FLORIDA DEPARTMENT OF TRANSPORTATION
Procurement Office
1074 Highway 90
Chipley, FL 32428
Phone: (850) 330-1374

BID No. DOT-ITB-21-3011-WE

Title: D3 RTMC Video Wall Display Replacement

Questions and Answers (Part 2)

Existing D3 RTMC Building-Audio System—Drawing

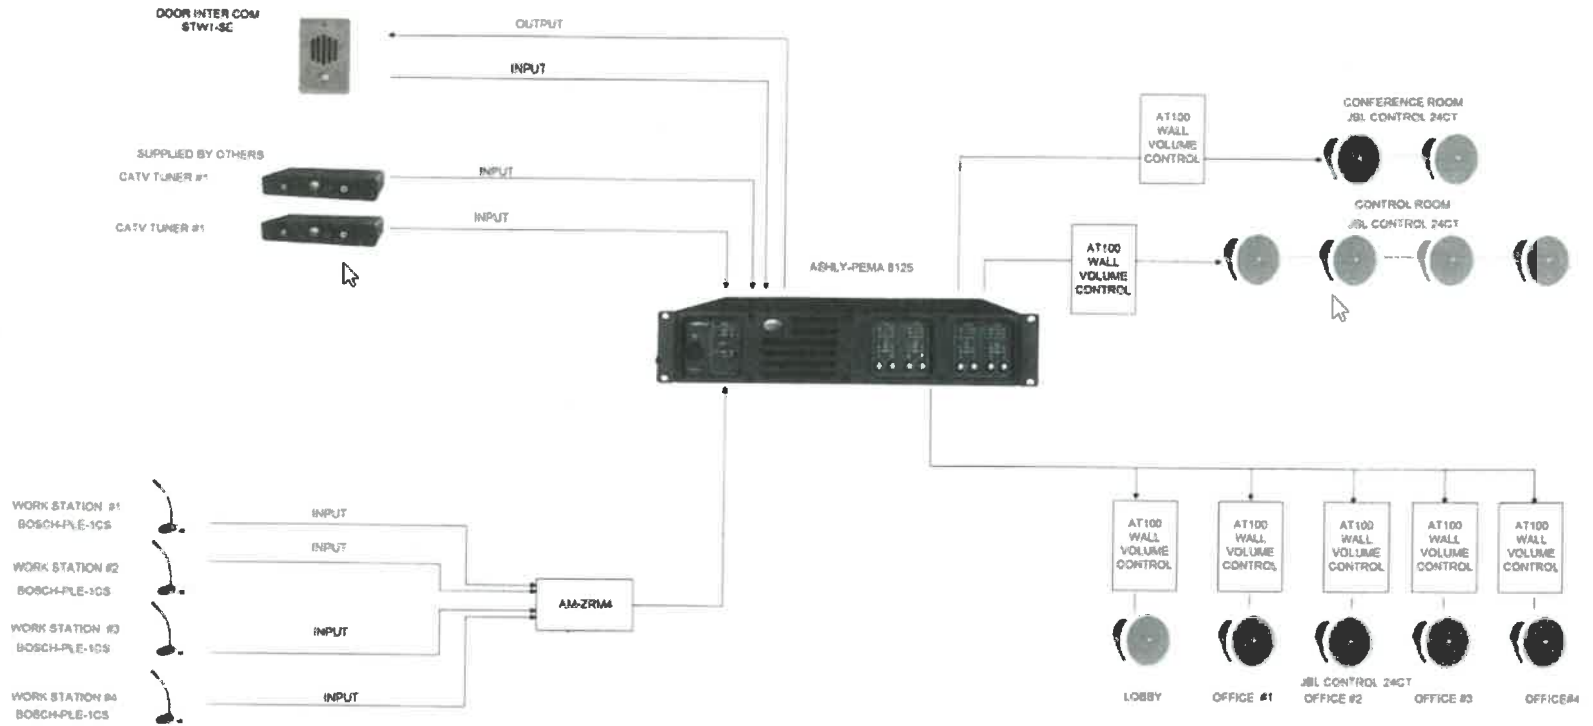
Question 54	<p>In Paragraph 4.3.5 Audio System</p> <p>The paragraph states there is to be a "New system to interface with the existing speaker system at the RTMC."</p> <p>Further in the Document there is reference to Zone control and source selection.</p> <p>a. Question: Is there an As-Built Drawing for current Audio system that shows the Input/Outputs?</p> <p>b. Question: Is there list for the input selections and Zoning?</p> <p>c. Question: What is the Make/Model Number of the Speakers currently installed?</p> <p>d. Question: Are the current speakers 70V/100V or 8 Ohm?</p> <p>e. Question: What is the Make/Model # of the current Amplifier?</p>

<p>Answer 54</p>	<p>Part a. See attached D3 RTMC Building-Audio System Drawing as a reference.</p> <p>Part b. See attached D3 RTMC Building-Audio System Drawing as a reference..</p> <p>Part c. Audio equipment are as listed below as answer to part e.</p> <p>Part d. Audio equipment are as listed below as answer to part e.</p> <p>Part e. <ul style="list-style-type: none"> - Protea Equipped Media Amplifier Network Power Amp 8 x 125W @ 4 Ohms & 25V w/ 8x8 DSP Processor Model 8125 Amplifier 70Volt ASHLY - Protea, Digital Signal Processing for the Protea-Equipped Media Amplifier ASHLY - Call Station: BOSCH - 4 Zone Rackmount Mono Routing Mixer (UL Approved) - 6 Momo Mic/Line Inputs Model ZMR4: Australian Monitor) - Control 24C with Transformer for amplifier/speakers: JBL - Attenuators, ATN 100W, 3DB, 1 GNG SS: Atlas Sound </p>
<p>Question 55</p>	<p>In Paragraph 4.3.7 Remote Video Wall Systems</p> <p>This paragraph and others state that if the Vendor alters the FDOT D3 network connections it will be the responsibility of the Vendor to provide any equipment required to extend...</p> <p>a. Question: Is there an As-Built Drawing for what the network currently has so that we may Bid the appropriate equipment if necessary?</p>
